SEI Welding Investigation

Abstract

The process of deciding on a method for welding the BSC support table, downtube/optics table, and the HAM optics and support tables is presented. The weld prototype and micrographs therefrom are discussed. Suggestions for new weld preps are illustrated. Results of a cursory check of residual stresses are presented. A stress relief cycle was performed on the coupons and the resulting warpage incurred is reviewed.

**Figure 3. Fillet welds: Upper 2 by Nosmas, Lower 2 by PSI
(magnification: 5x)**

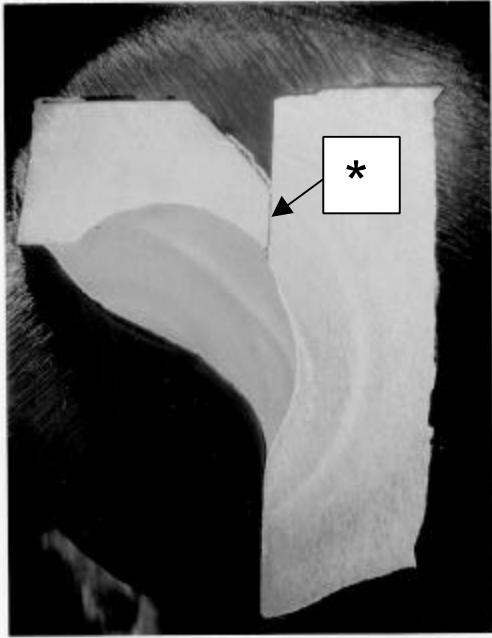
The design of the weld prep on the fillet weld initially used a small land of 4.8 mm (.187") and a 45° chamfer. This was patterned after recommendations in a Stanford Linear Accelerator Center (SLAC) document. Neither of the 2 shops was able to achieve a full penetration weld through the 4.8 mm (.187") land, thereby leaving a virtual leak. It is felt that the SLAC recommendation was based on stainless steel, a poor heat conductor. Figure 3 shows the attempts by Nosmas and PSI respectively. Notice the virtual leaks on each of the macrographs.

* = Virtual leak

This aluminum structure permitted heat to be rapidly diverted into the 1" plate. New samples were made with the weld prep coming to a sharp edge. Both vendors achieved penetration, although not necessarily with acceptable results. See Figures 4 through 8.

Figure 4. Nosmas 2nd attempt (magnification: top 5x, bottom left 200x, and bottom right 100x)

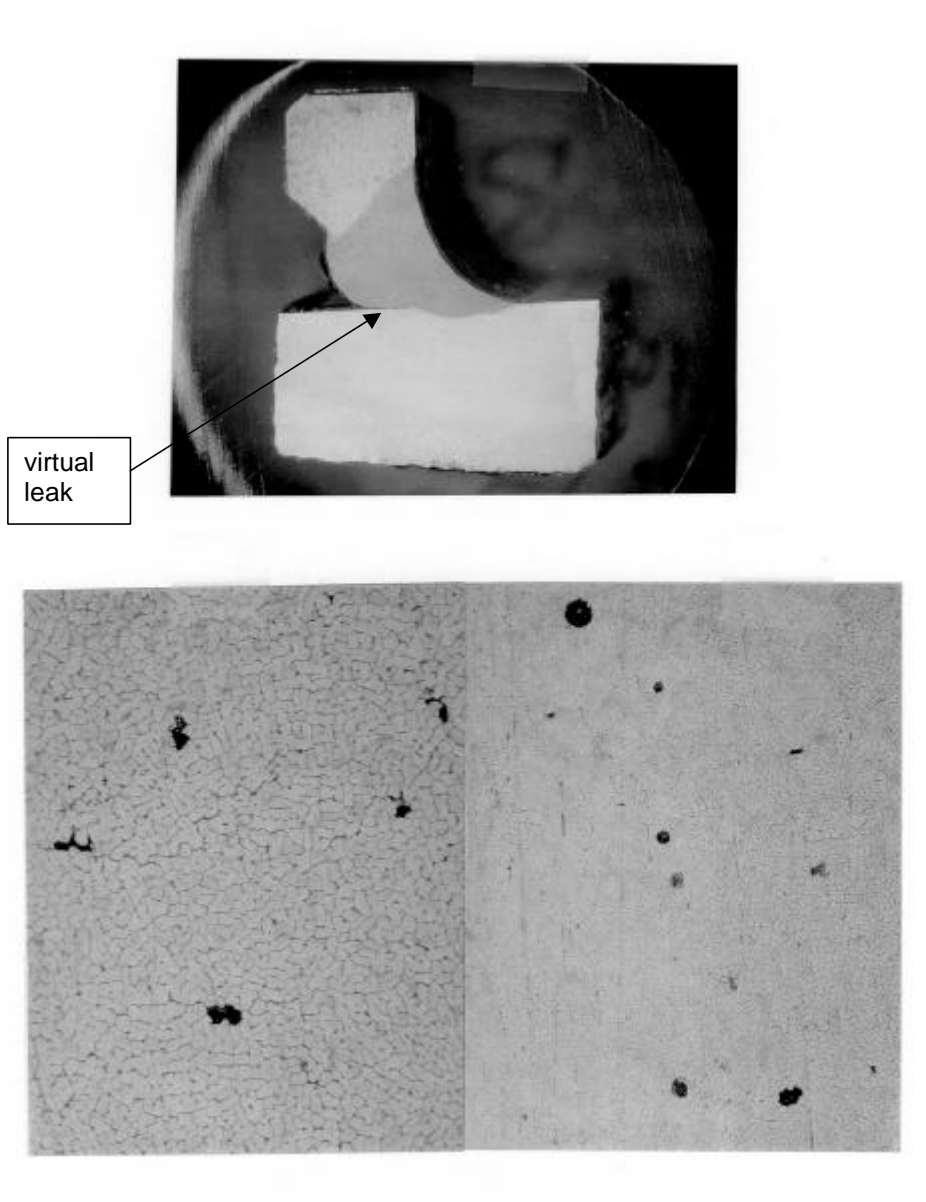
Note the pronounced virtual leak in the top photo of Figure 4. The weld penetrated the 1/4" plate, but did not fuse with the 1" plate. The lower left photo shows a number of very small shrinkage voids in the weld bead. Very small pores and some shrinkage were identified near the weld surface, as shown in the lower right photo.

Figure 5. PSI's 2nd attempt. (magnification: top 5x, bottom 100x)

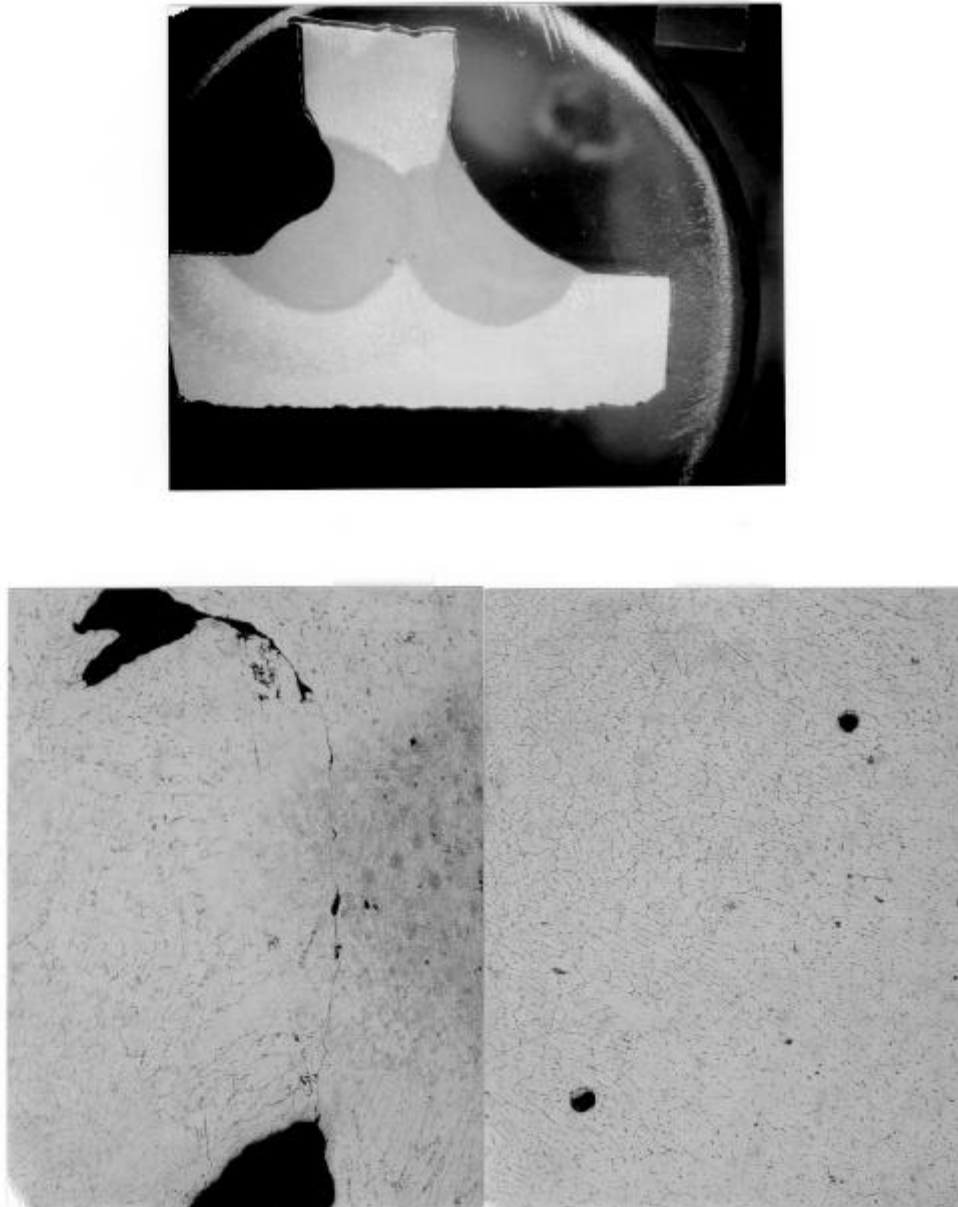
Figure 5 shows a double fillet weld done with a double beveled weld prep. Significant undercut at the weld surface is noted at one side resulting in a thinner cross-section at the weld than the thickness of the 1/4" plate. Interpenetration of the 2 fillet welds is almost complete except for a small central defect area. Also note the large heat affected zone adjacent to the fillet with the undercut, as shown in the upper photo. A small crack extending to the root area of both welds ending in void areas is seen in the lower left photo. A number of small pores were also identified. The lower right photo is typical.

Figure 6. PSI specimen (magnification: upper 5x, lower 100x)

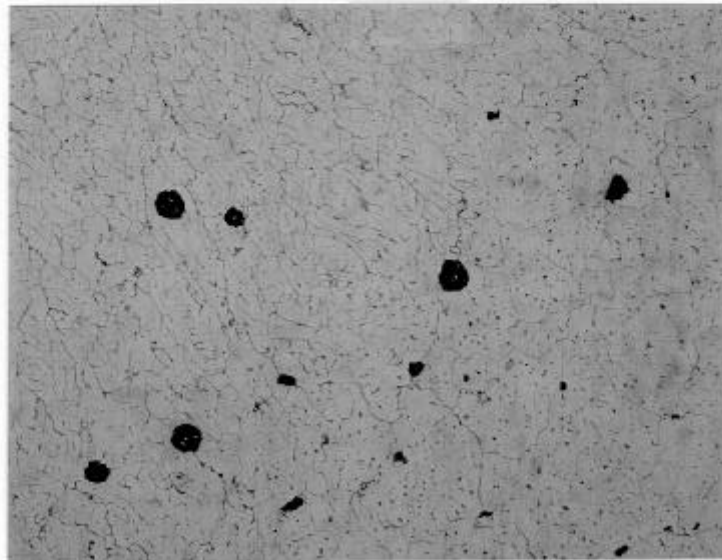
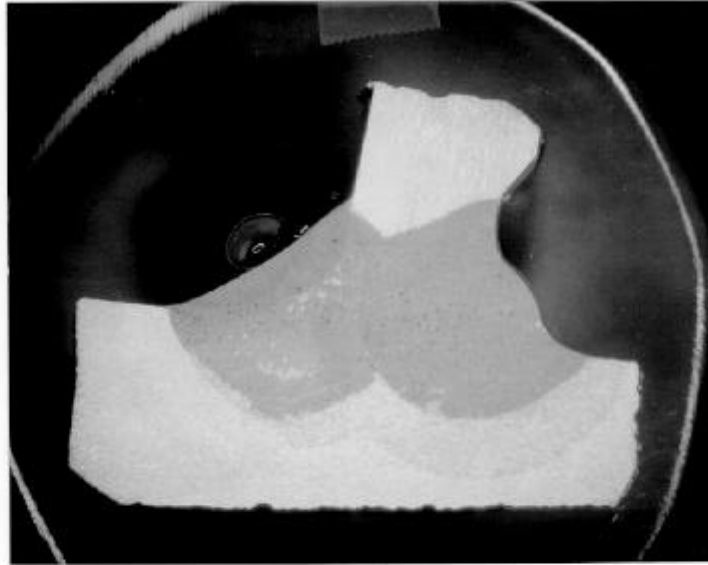
Shown below in Figure 6 is another PSI specimen. The weld prep was a 30° chamfer on one side, with welding on both sides. The welds have fully penetrated the beveled plate with no evidence of remaining unwelded areas. The lower photo shows some of the many small pores scattered throughout the fillet welds.

**Figure 7. Another weld coupon by PSI (magnification: top 5x,
bottom 50x)**

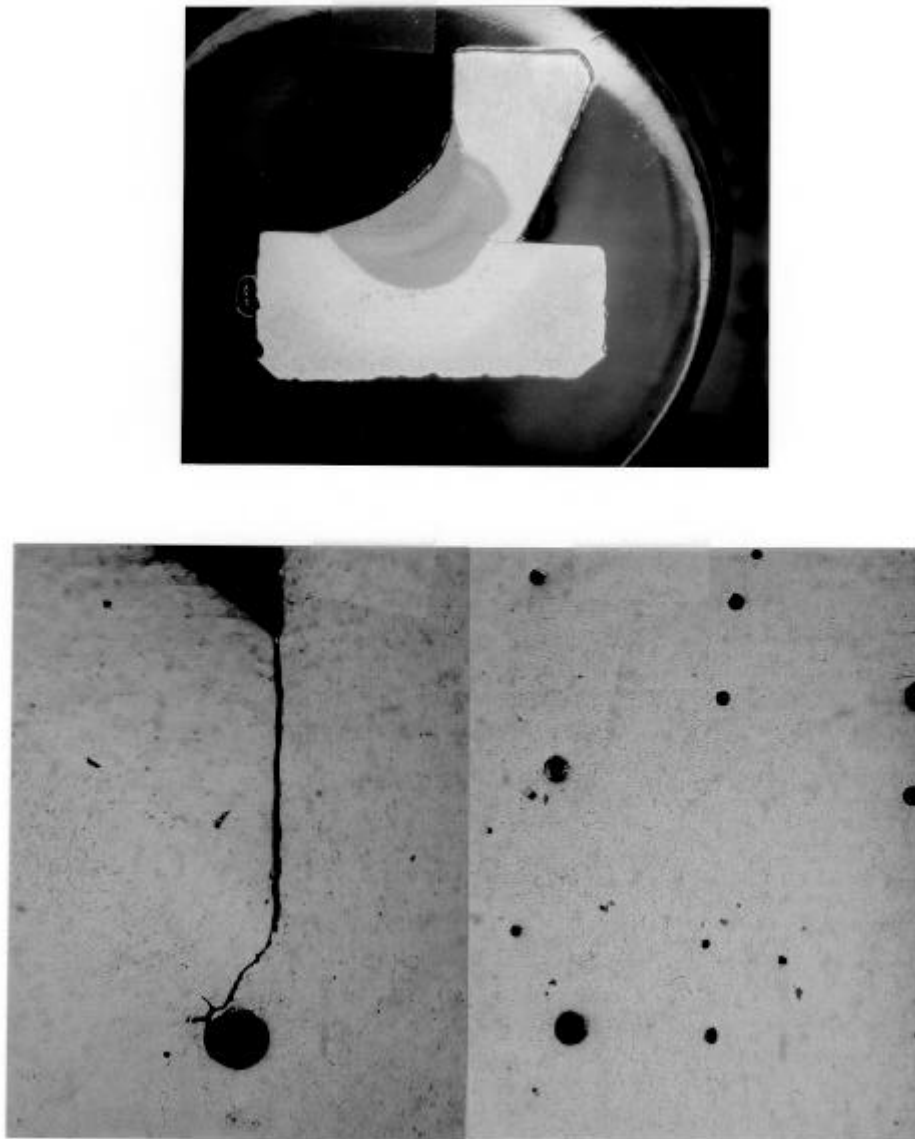
Figure 7 shows a single chamfered weld prep with a fillet weld on one side. The weld shows a lack of penetration in the weld root and porosity in the top run which is highly concave, as seen in the top photo. The lack of penetration is clearly seen in the lower left photo with a small shrinkage crack extending into the weld that has a pore attached. Porosity in the top weld run is prevalent and illustrated in the lower right photo.

**Figure 8. A PSI weld specimen using a single chamfer weld prep.
(magnification: top 5x, lower left 50x, lower right 100x)**

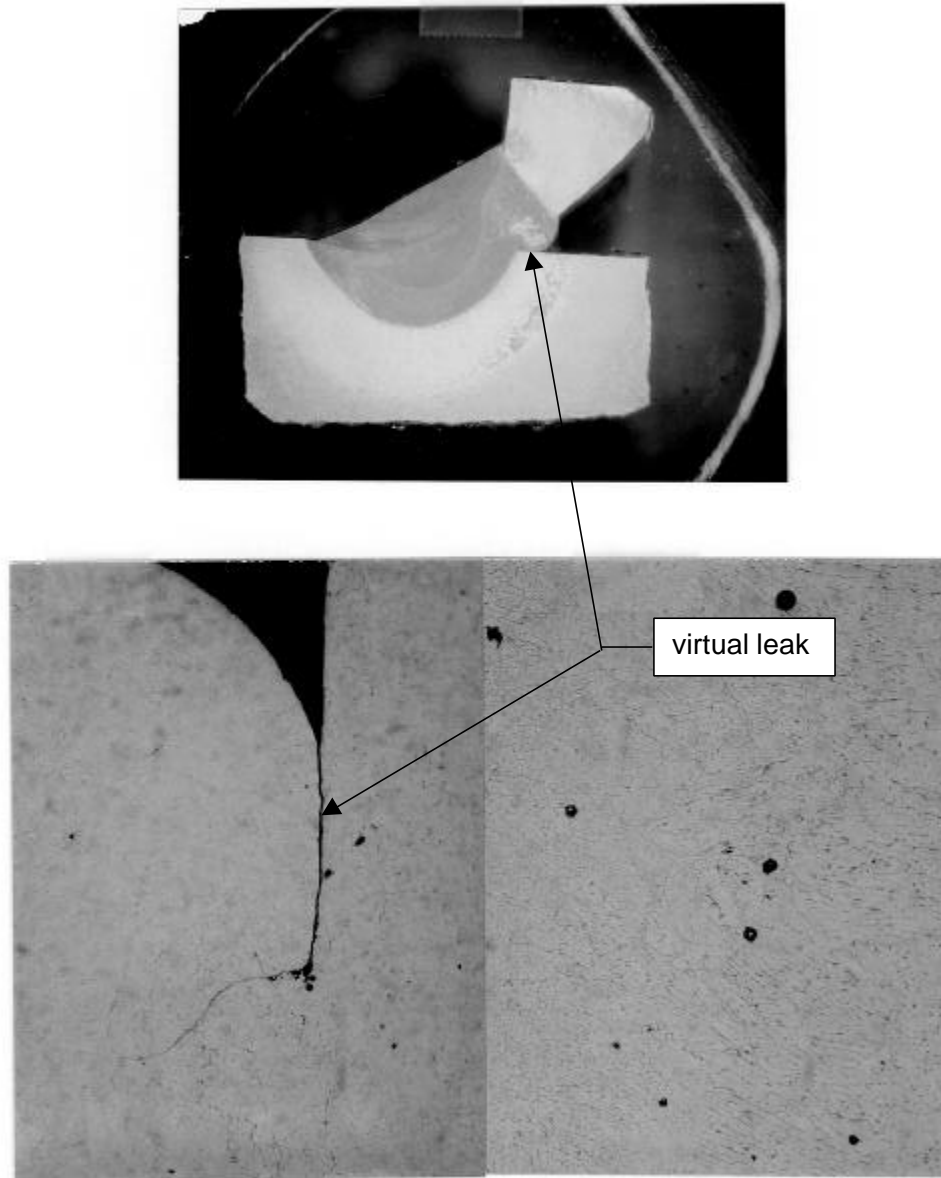
Figure 8 shows the result of using a single chamfered weld prep and a fillet weld on the side opposite the chamfer. The weld is flat topped and displaced toward the thicker material, as shown in the upper photo. Some lack of fusion is present in the weld root. The lower left photo shows a small crack extending from this lack of fusion area. The weld also contains very fine porosity in the top run of the weld, as presented in the lower right photo.

Figure 9. Suggested fillet weld design

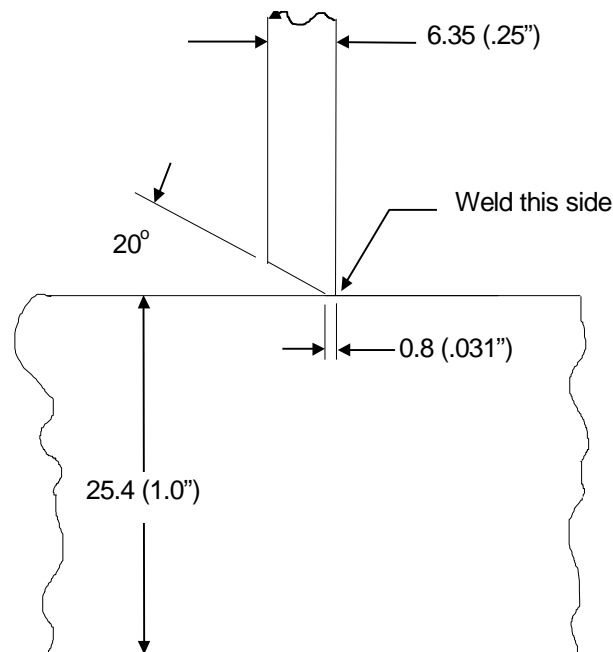
Subsequent discussion with Dr. Thomas W. Eagar of M.I.T. brought forth the recommendation that that a small land be left on the weld prep, lest the sharp corner bite into the thicker plate during welding. The latter was observed upon examining the second set of samples that had the sharp corner. Figure 9 shows Dr. Eagar's suggestion for the fillet weld. He also suggested that the first pass be autogenous DC, straight polarity, with a 50/50 argon/helium mix. The second pass should be AC with 4043 filler. Dr. Eagar further stated that, inasmuch, as welding is an art, the welder is given the freedom to explore alternatives that achieve the quality of weld that is desired. Additional weld specimens will be required to prove this design.

Figure 10. Initial design of the plug weld

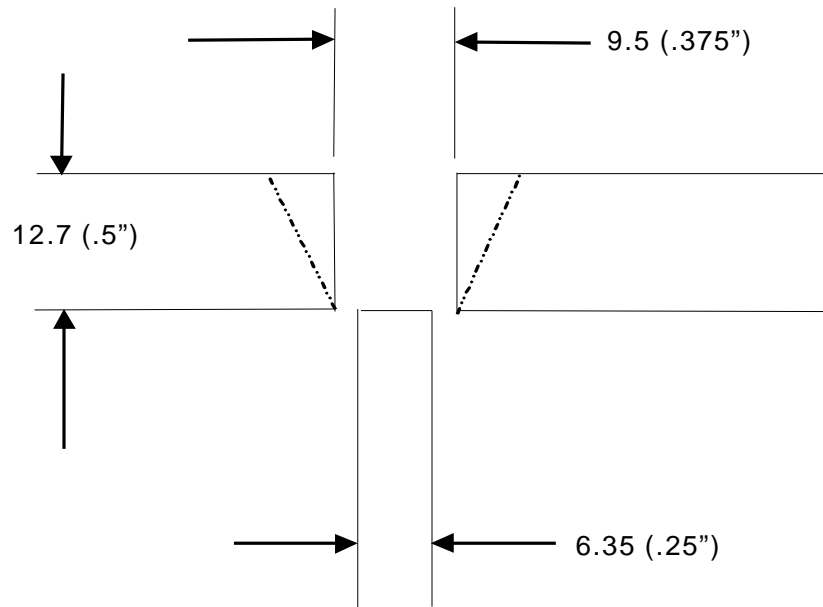
The initial design of the plug weld at the bottom of the HAM optics table and the top of the BSC optics able is shown in Figure 10. The phantom lines indicate where both vendors requested opening the slot to improve welding access.

Figure 11. Micrographs of plug welds. (magnification 5x)

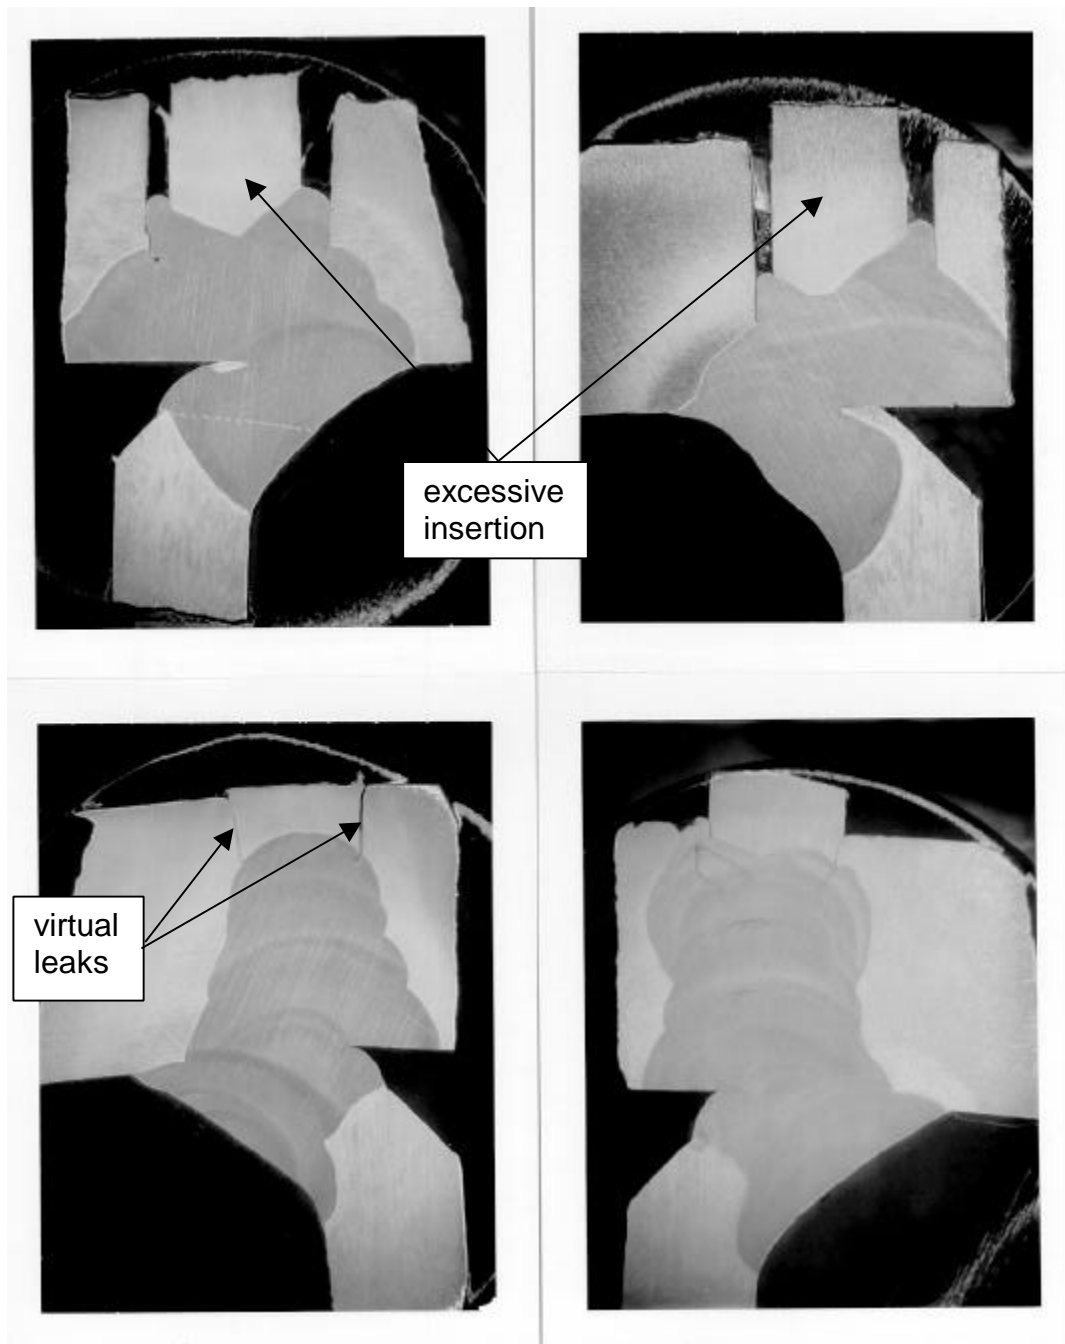
Unfortunately, both vendors allowed the smaller plate to protrude excessively into the slot. The results were large virtual leaks. See Figure 11.

The upper two specimens were done by Nosmas, and the lower two, by PSI. The lower leg, in all 4 photos, represents the downtube, as it is welded to the top part of the BSC optics table. The leg in the top center of all 4 pictures represents the 1/4" core element of the optics table. The remainder is the 1/2" plate that forms the top part of the optics table. All photos show large virtual leaks.

Figure 12. Nosmas 2nd plug weld. (magnification: top 5x, bottom 100x)

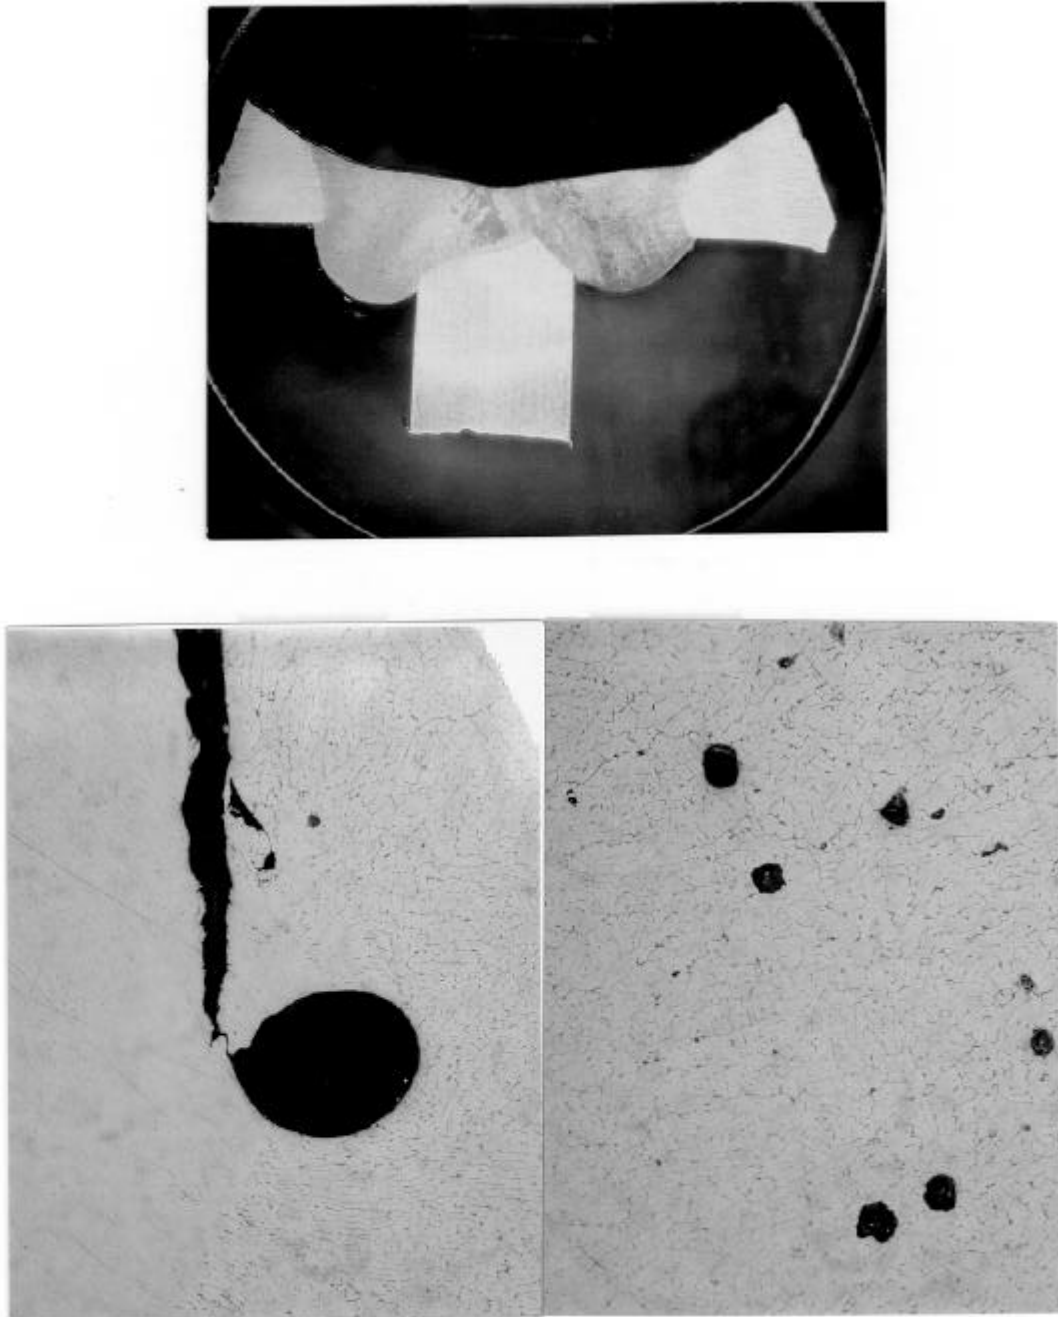
Nosmas made another weld sample with their own modified weld prep. They machined large 60° chamfers on the 1/2" plate. See Figure 12.

Significant weld penetration has been made on either side of the central plate. The welds are sound in general, but the penetration appears rather excessive. A large pore was found at the root of the weld with a small amount of oxide enfoldment, as shown at the lower left of Figure 12. The welds also contained a number of very small voids and shrinkage cavities, as shown in the lower right photo.
